- **COOLING SYSTEM—LEAKING RADIATOR HOSE JOINT—4.9L/5.0L/5.8L/7.3L DIT/7.5L—UPGRADED HOSE CLAMPS**

**Article No.
95-6-16**

FORD: 1995-1996 BRONCO, ECONOLINE, F-150-350 SERIES

Figure 1 - Article 95-6-16

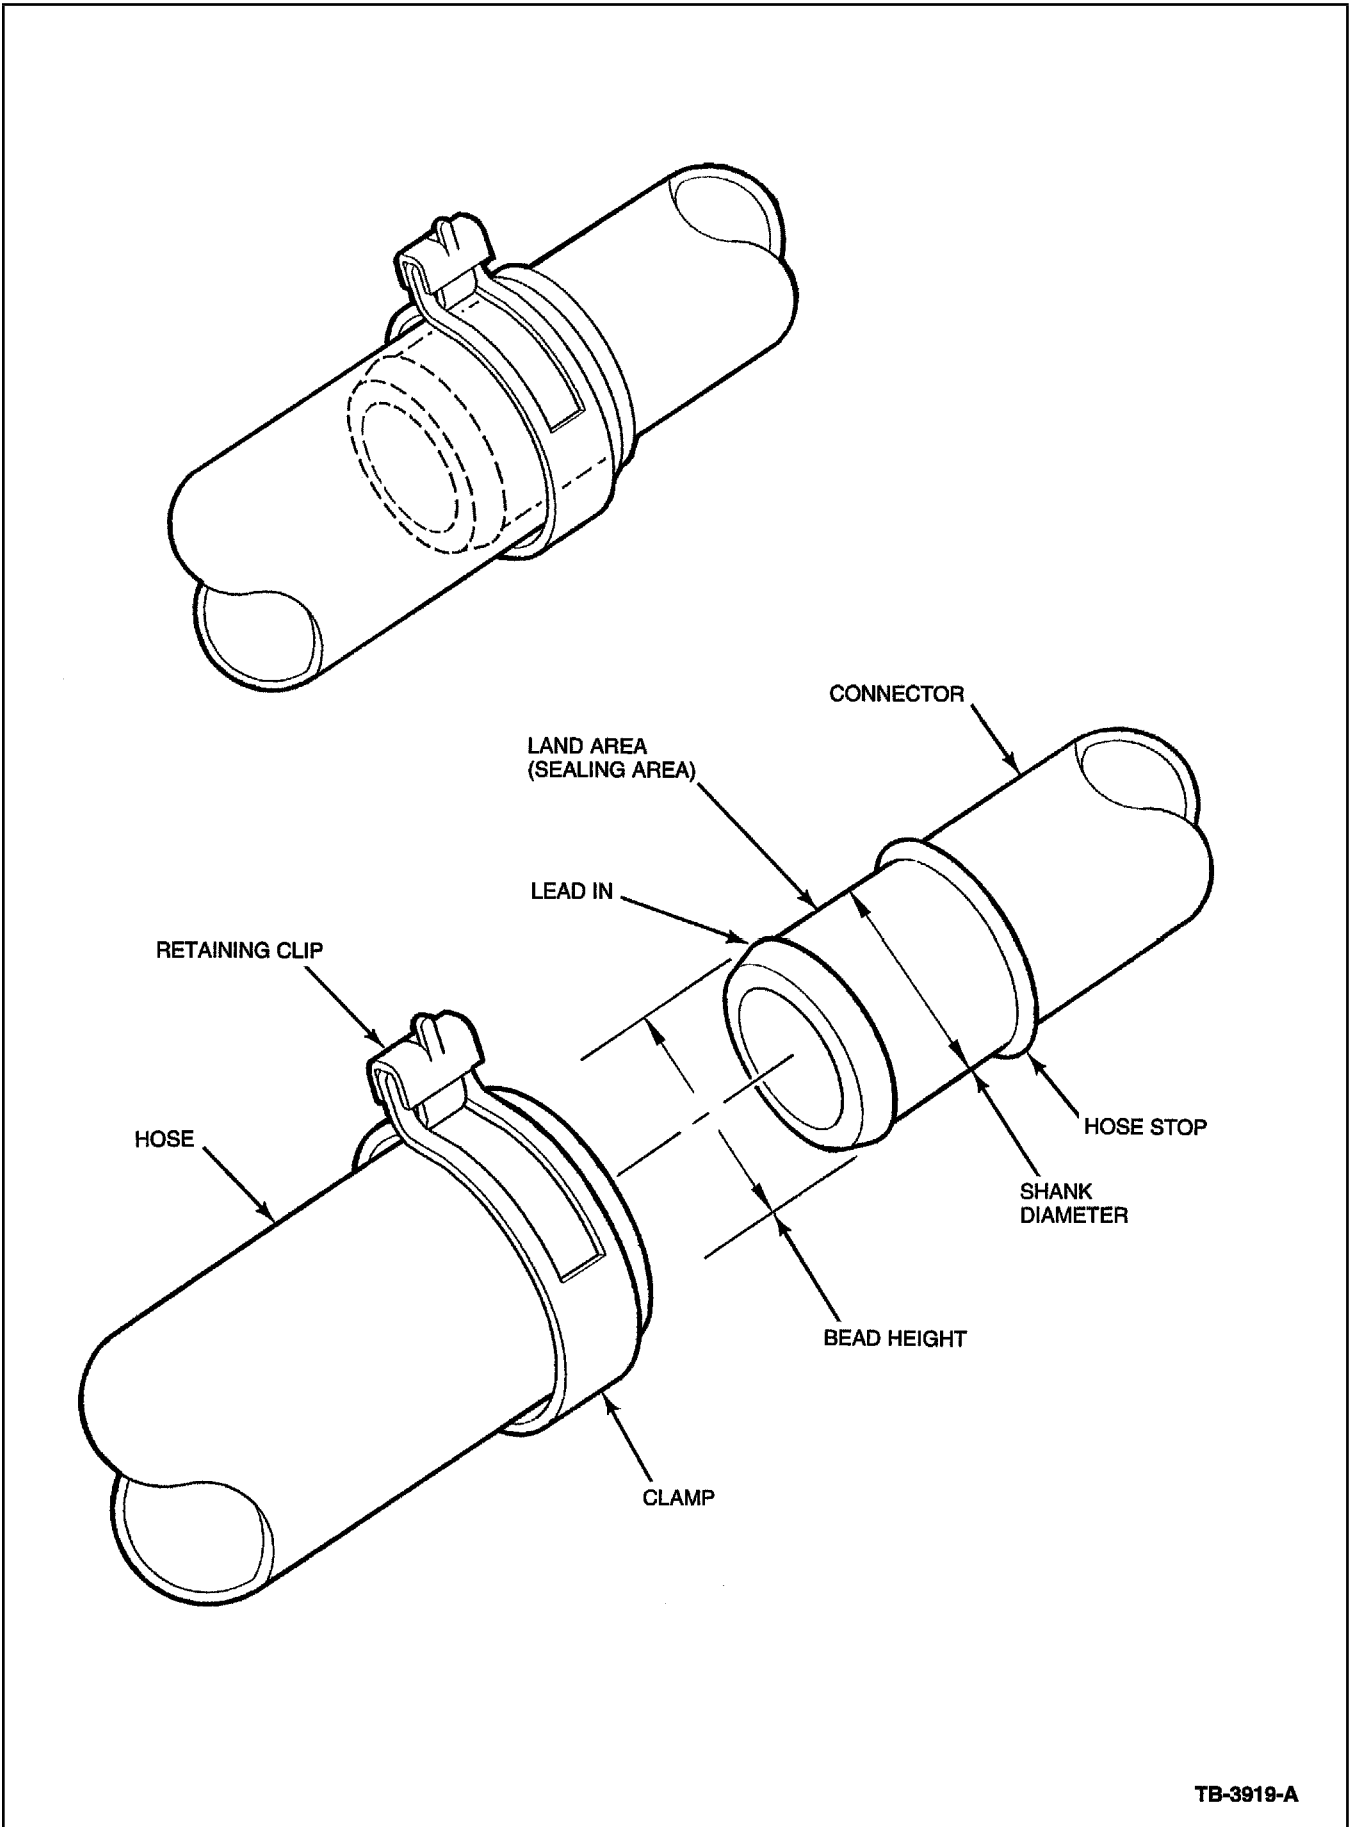
2. Reseat the clamp by using a pair of pliers or vise grips to squeeze the clamp tangs together (loosen the clamp), reseal the hose, then re-release the clamp. Pay close attention that the clamp is straight (perpendicular to the hose) and is **not** cocked over the bead (Figure 1).
3. Pressure test the system again. If the leak persists, check the radiator hose clamp for damage. If damage is observed, replace the damaged part per the following installation steps. The clamps to be used are as follows:

2. Release the "Mega" clamp by carefully removing the retaining clip using pliers or vise grips. During removal, **the clip should be held securely** at all times. Do not pry or pop the clip off the clamp.
3. Check that the clamp is straight, fully released and seated on the sealing area of the hose and connector. The clamp should **not** be partially or completely cocked over or on top of the bead at the end of the connector. The connector, radiator hose and clamp are shown in Figure 1.

“Mega” hose clamps are to be used, if needed, because they have 30% more clamping force than clamps used in the past. They expand and contract with the thermal cycling of the joint, thus retaining their clamp load and efficiently sealing the joint over long periods of time. The screw-type dual-wire and worm gear style band clamps are less robust under climatic and system thermal cycling .
